City of Portland, Maine – Building or Use Permit Application 389 Congress Street, 04101, Tel: (207) 874-8703, FAX: 874-8716

Location of Construction: 15 Franklin St		Owner: M & A Partners	Phone: 775-2100	Permit No: 981021
Owner Address: 120 Exchange St Ptd, ME 04101		Lessee/Buyer's Name: Ogden Environmental	Phone:	BusinessName:
Contractor Name: Owner		Address:		Phone:
Past Use: Vacant	Proposed Use: Office	COST OF WORK: \$ 40,000.00	PERMIT FEE: \$ 220.00	<div style="border: 2px solid black; padding: 5px; text-align: center;"> PERMIT ISSUED SEP 11 1998 CITY OF PORTLAND </div>
		FIRE DEPT. <input checked="" type="checkbox"/> Approved <input type="checkbox"/> Denied	INSPECTION: Use Group: B Type: 38 BOCA 90	
		Signature: <i>[Signature]</i>	Signature: <i>[Signature]</i>	
Proposed Project Description: Tenant buildout for office use (3rd floor)		PEDESTRIAN ACTIVITIES DISTRICT (P.A.D.) Action: <input type="checkbox"/> Approved <input type="checkbox"/> Approved with Conditions <input type="checkbox"/> Denied		Zone: B-3 CBL: 029-M-004 Zoning Approval: <i>[Signature]</i> <input type="checkbox"/> Special Zone or Reviews <input type="checkbox"/> Shoreland <input type="checkbox"/> Wetland <inpu

Job 007738	Truss FD1	Truss Type ROOF TRUSS	City 19	Ply 1	Y520104
---------------	--------------	--------------------------	------------	----------	---------

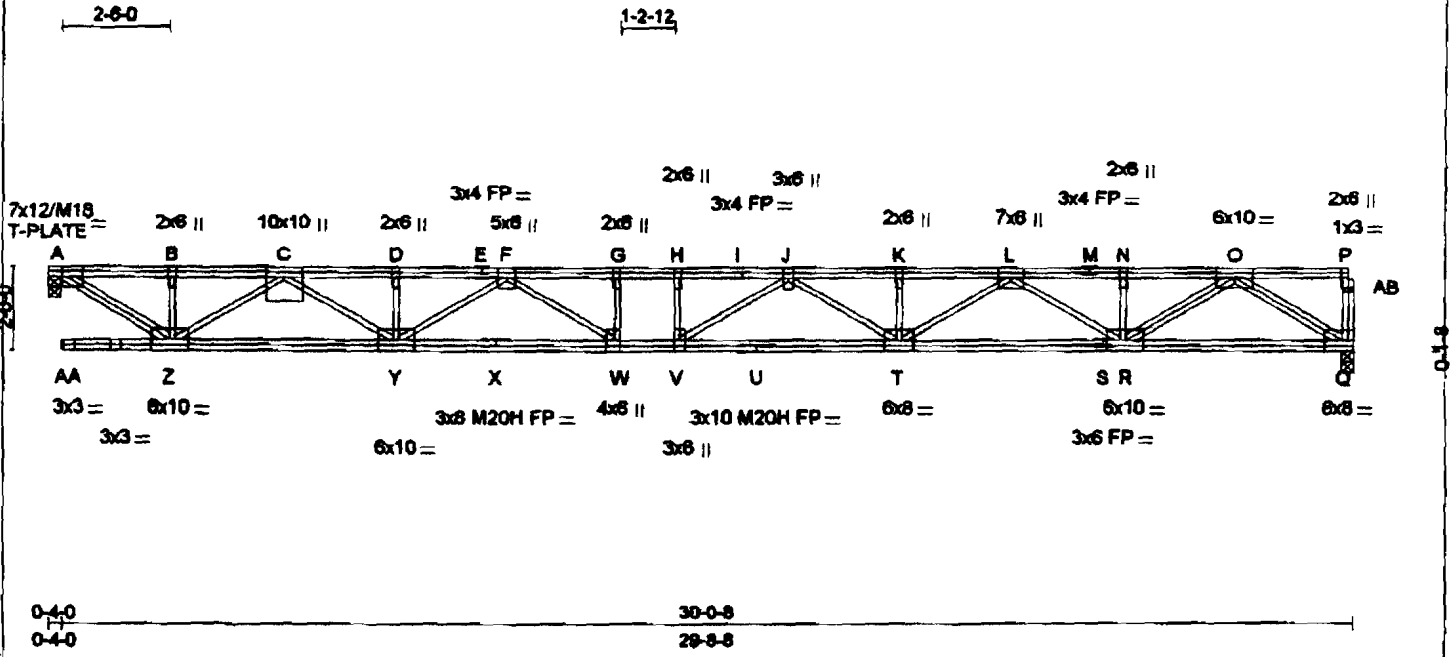
11/13/98 Final OK request Engineers Specs for Trusses before
CO issued.

11/14/98 Truss Specs rec'd
